Re: Part 3A Project Application – Summer Hill Flour Mills (MP10_0180)

Subject: Exhibition of Project Application for Stage 1 of the former Allied Mills Flour Mill Redevelopment, 2-32 Smith Street, Summer Hill (MP 10_0180)

Attachment 2: Response to Assessment Issues

OPTION 3a
Upstream High Level RCBC
and Concrete Flow Channel

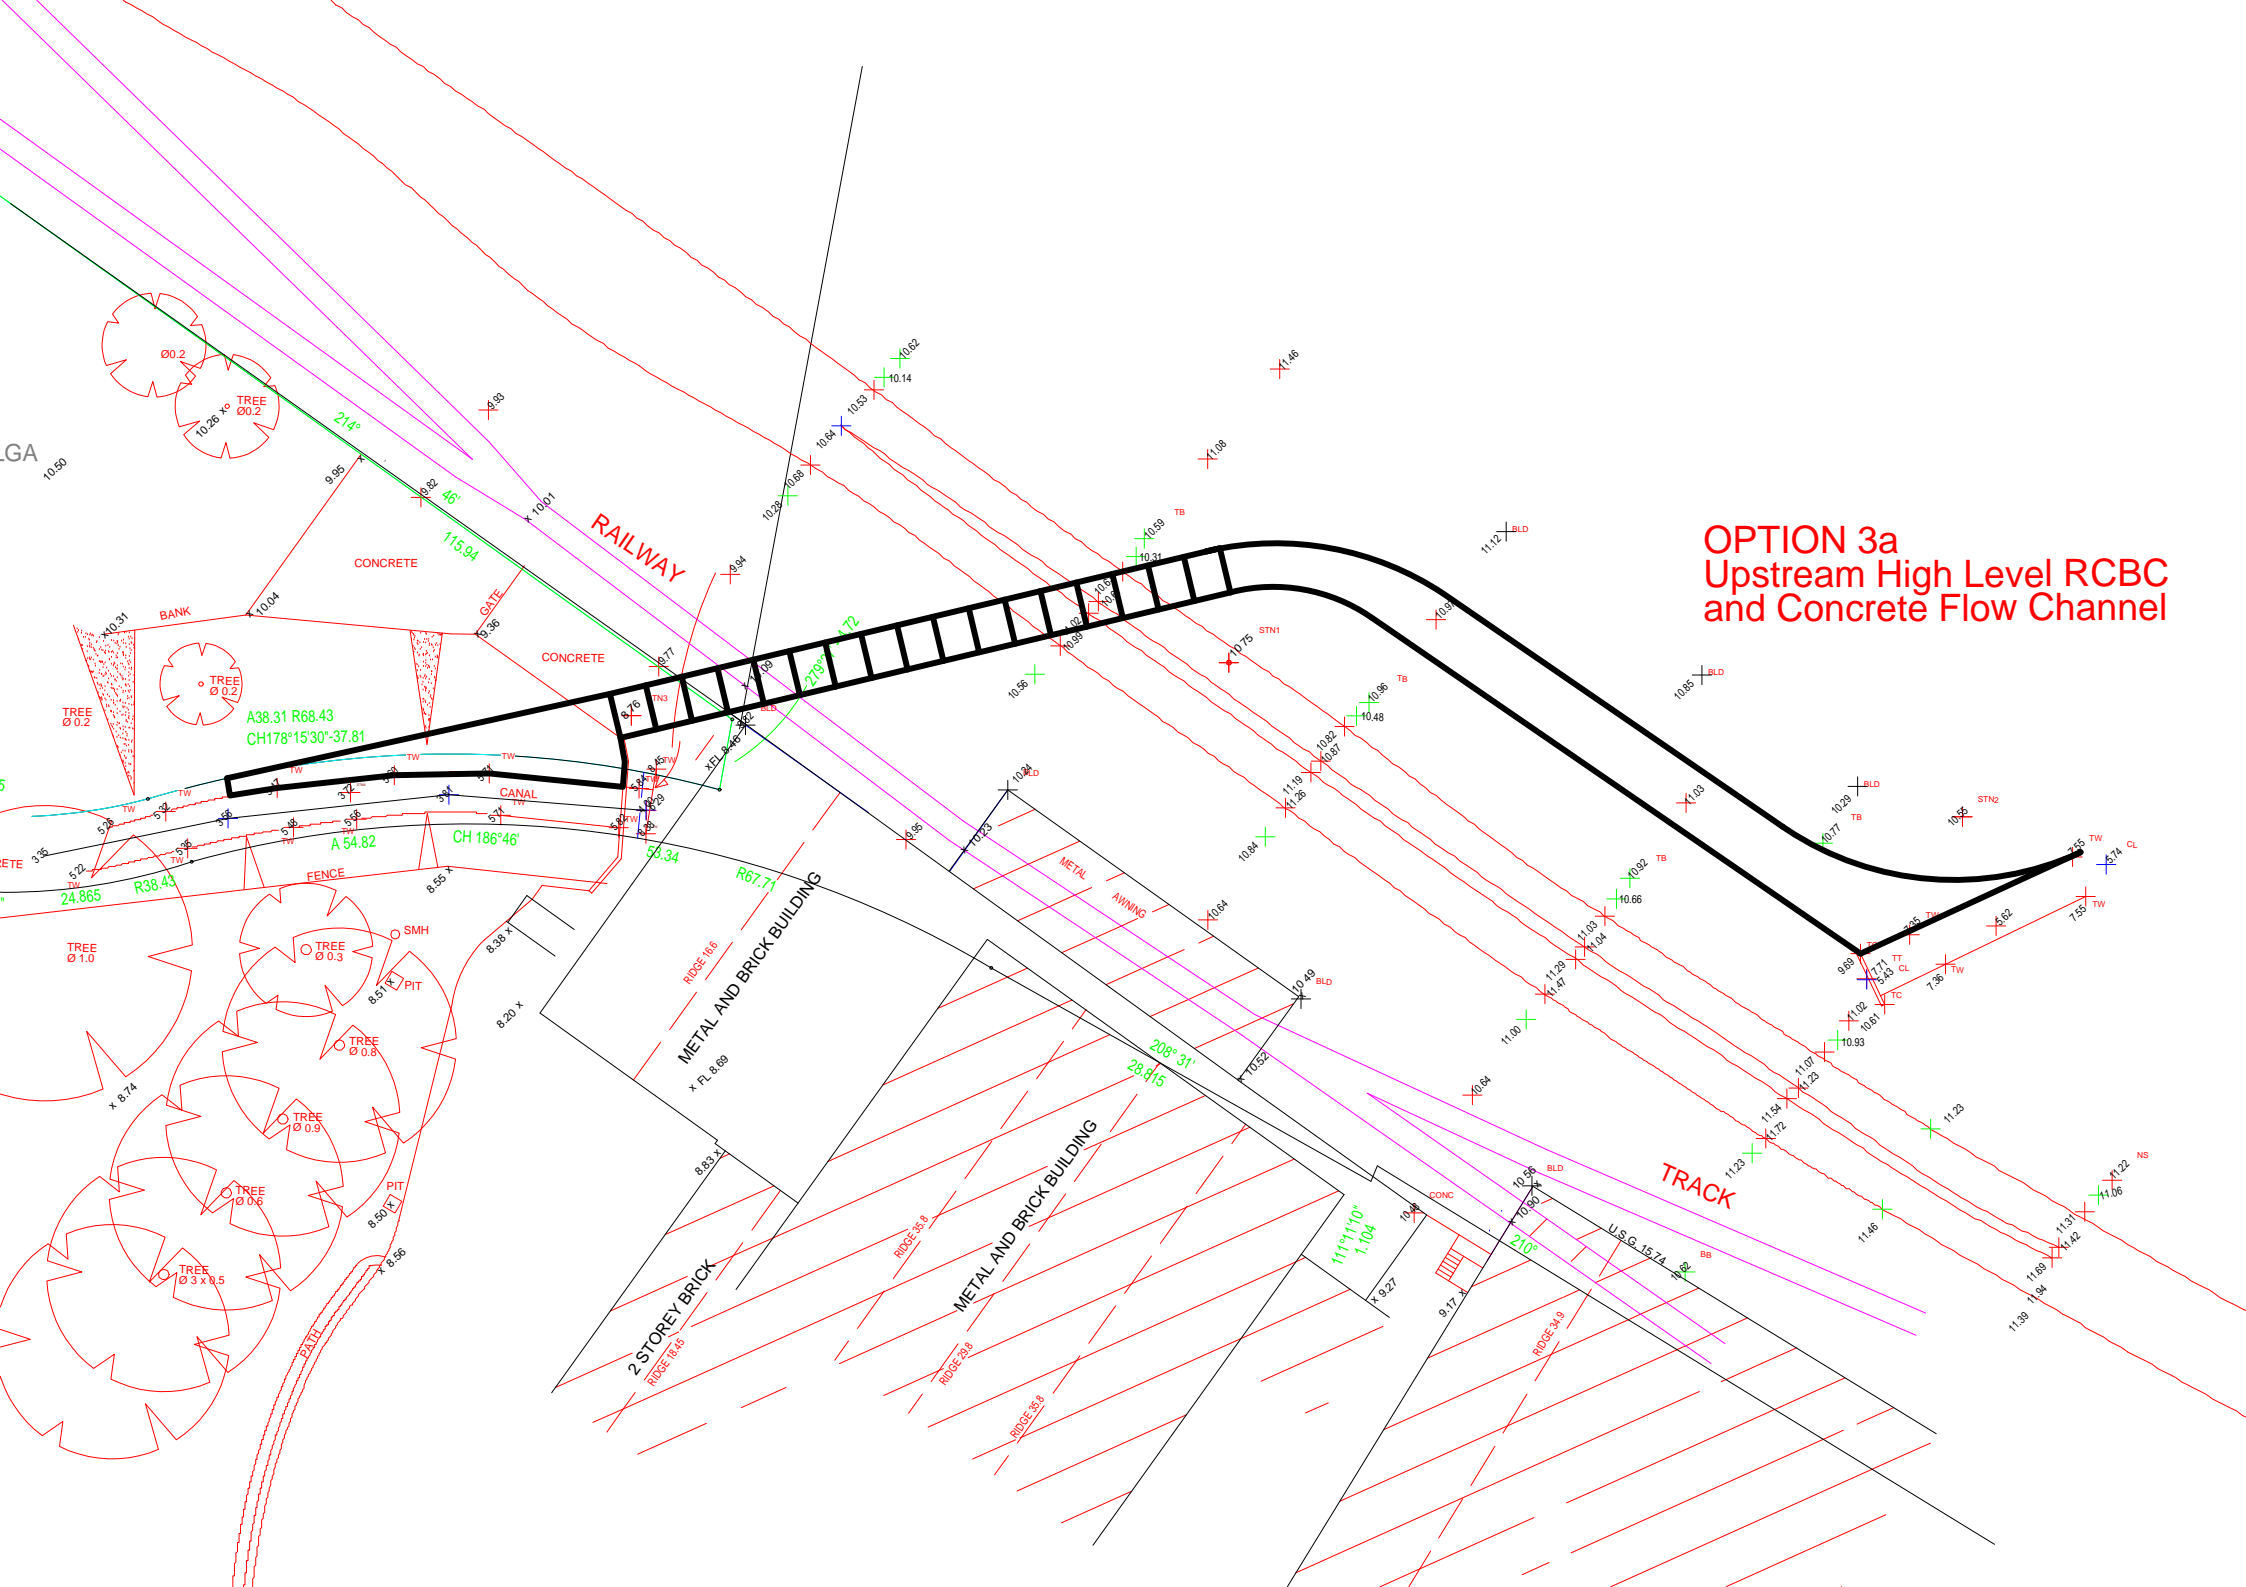
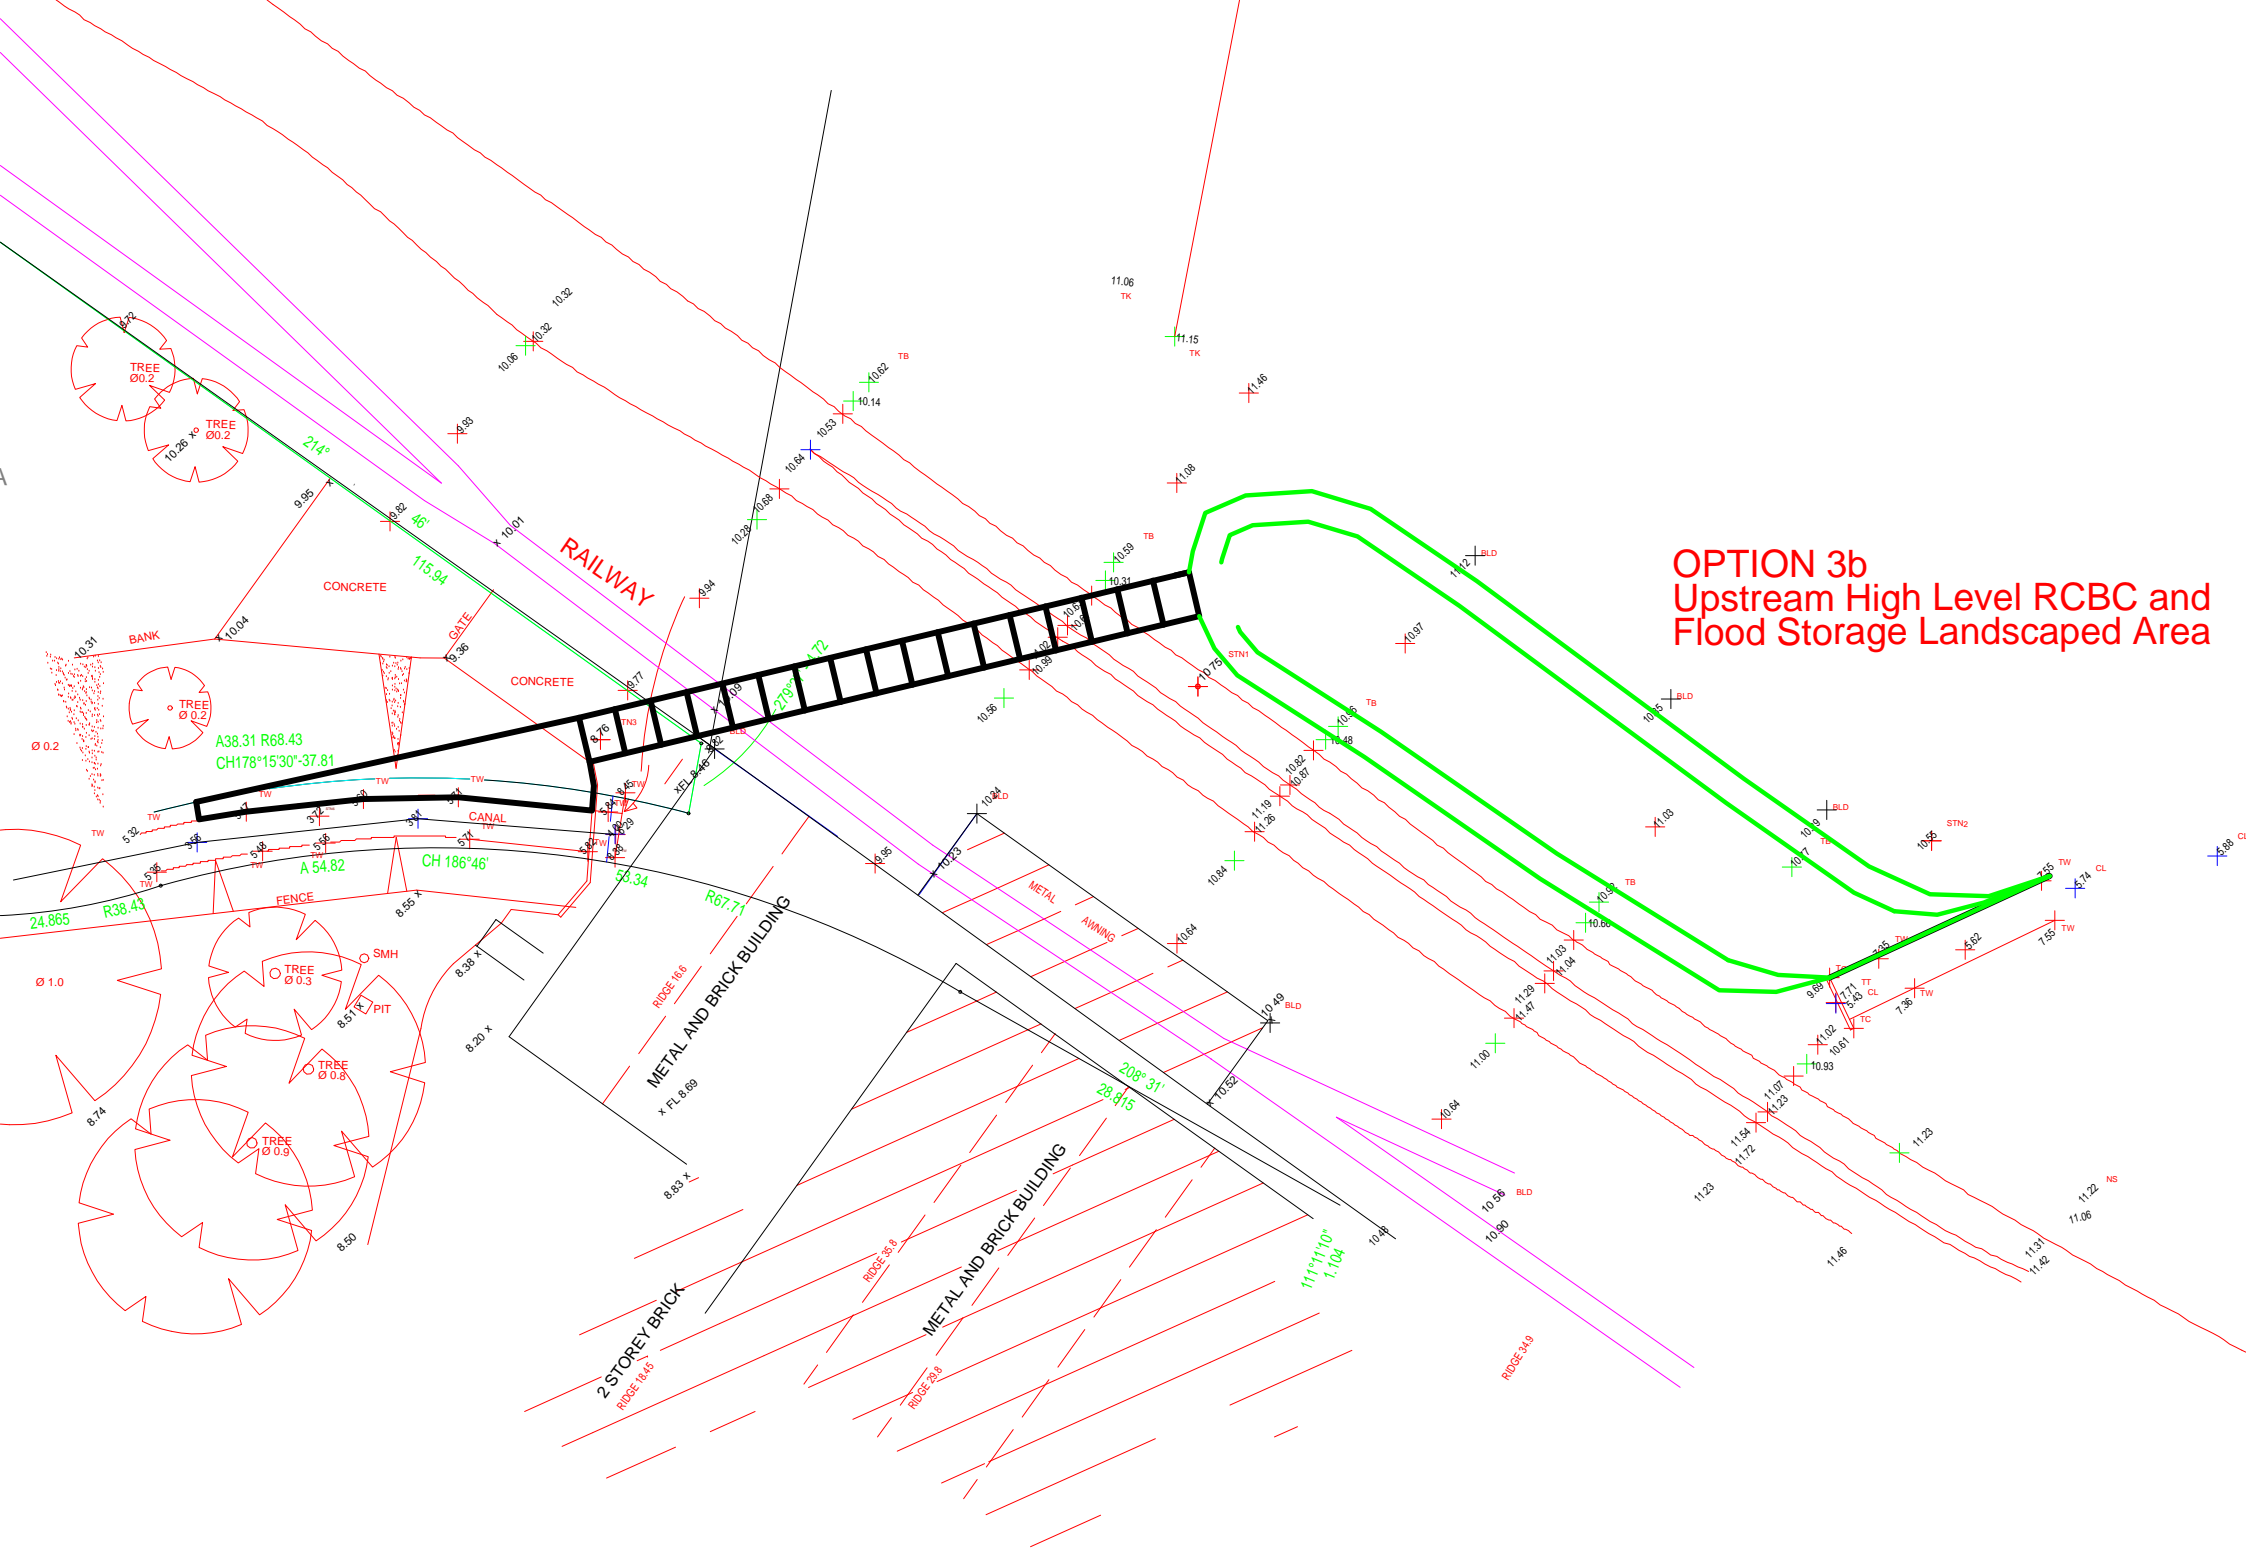
The proposed strategy and site design will need to be fine-tuned to work in with the broader operation of the local floodplain. In particular I refer to the development of the rail line and properties on the eastern side of the rail line.

There are investigations currently underway to develop additional pipe capacity under the railway line, very broadly along the lines of the previously discussed Options 3a and 3b (attached for information). These options would involve the connection of a large pipeline (preliminary estimate 1500mm diameter) at the headwall where the Sydney Water culvert currently 'daylights' just within your property.

Based on the plans submitted to date Sydney Water does not anticipate any significant adverse impact on your property. There is some potential for the proposed pipeline to reduce the flood impacts and the extent of necessary flood protection works along your boundary and within the railway corridor.

Sydney Water would request a statement of commitment on your behalf to participate cooperatively in the process of design and implementation of flood mitigation works within the broader floodplain.
